Technical Service Note 31-09 (Rev. “C”- Torque change.)

SUBJECT: Fifth Wheel Plate to Outboard Mounting Angle Fasteners.

PRODUCTS: Cascadia vehicles equipped with plate mounted fifth wheels and outboard mounting angles.

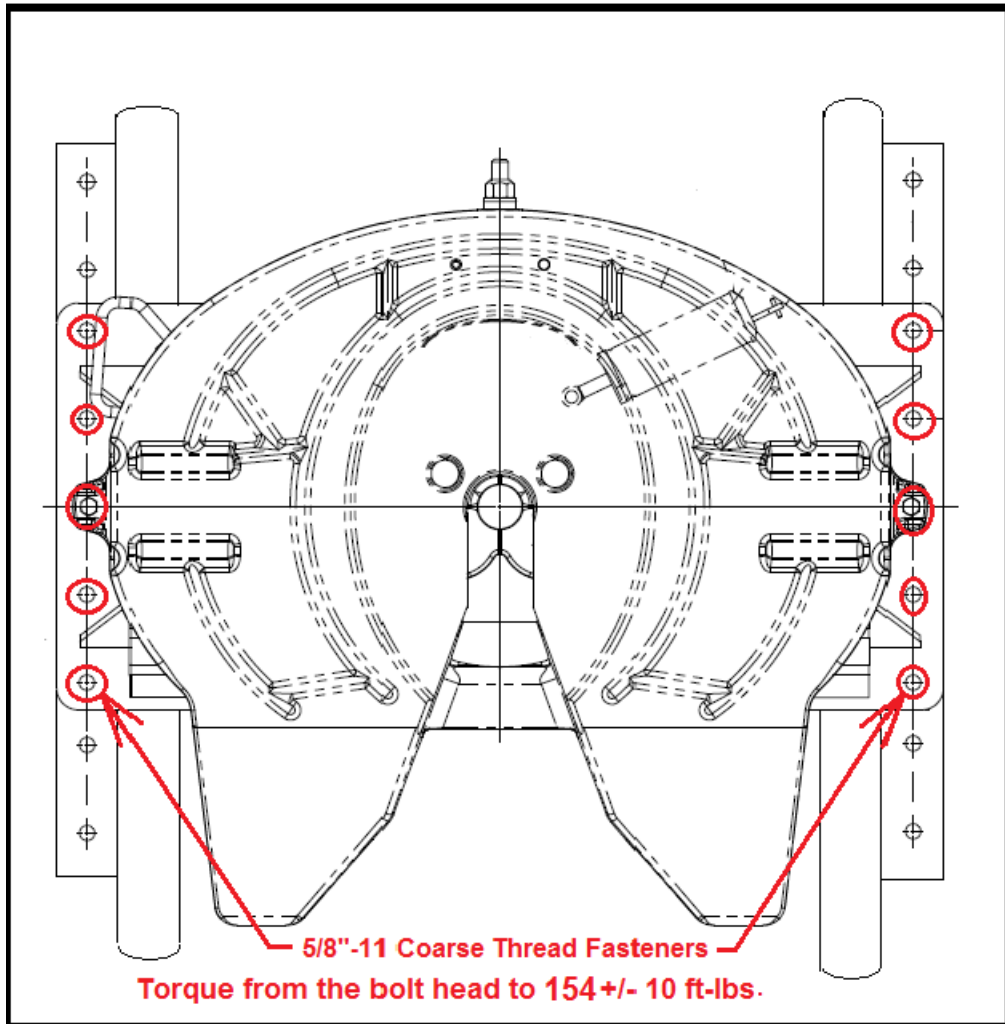
Inspect the ten 5/8” fasteners that attach the fifth wheel plate to the outboard angles to confirm they are torqued to the appropriate specification.

If any of the fasteners are below the minimum torque, replace all ten fasteners with new hardware.

If the Fifth Wheel is being relocated to an alternate position on the outboard angles replace all ten fasteners with new hardware.

Note: Torque from the bolt head to 154 +/- 10 ft-lbs.
